**GULF STATES UTILITIES COMPANY**

November 29, 1983

River Bend Station-Units 1 & 2  
Docket Nos. 50-458/50-459

## ATTACHMENT 1

FIGURE 7.4-3

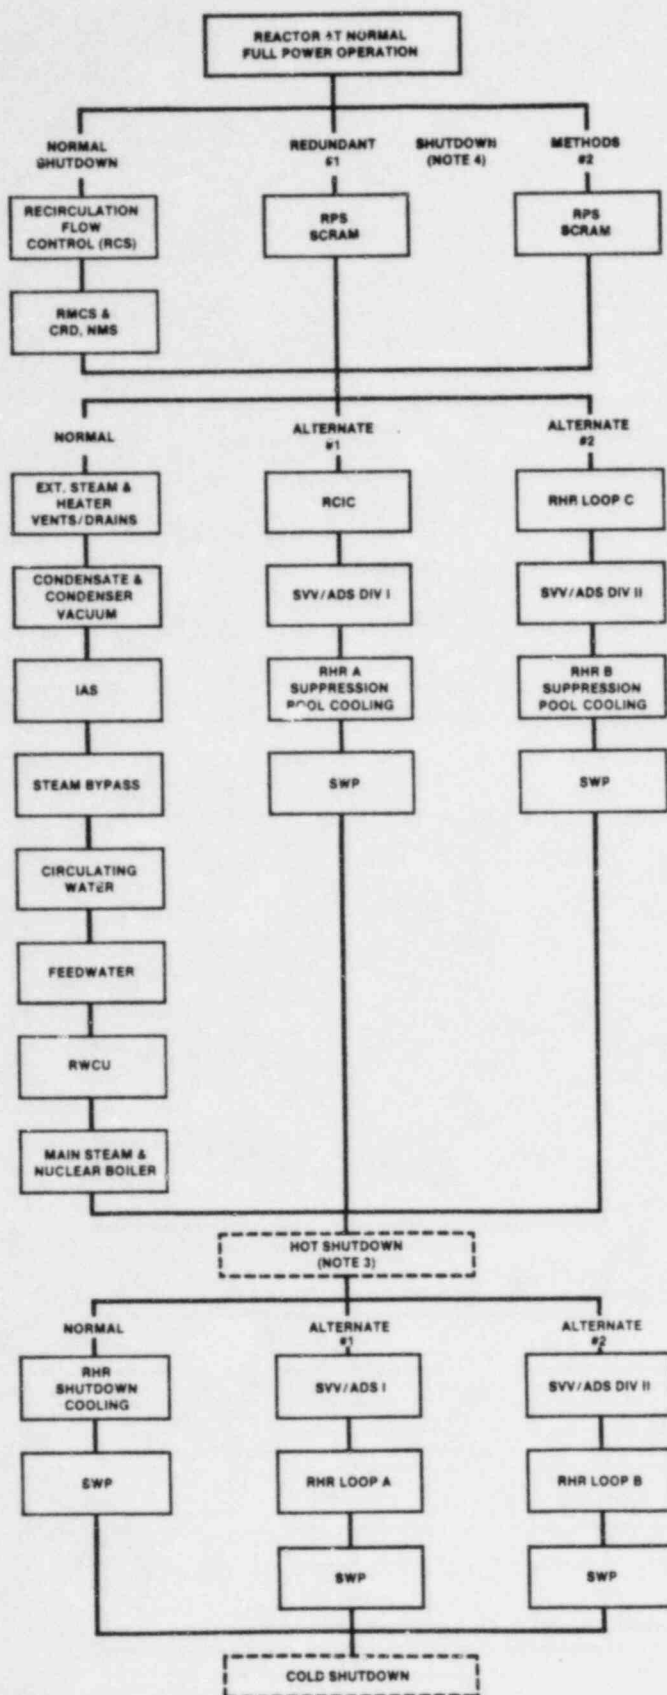
In the process of revising the RBS Fire Hazard Analysis and providing responses to the items contained in the November 8, 1983 docketed correspondence, various pages, tables, and figures were revised to maintain consistency. These additional changes have been included in Enclosure 3.
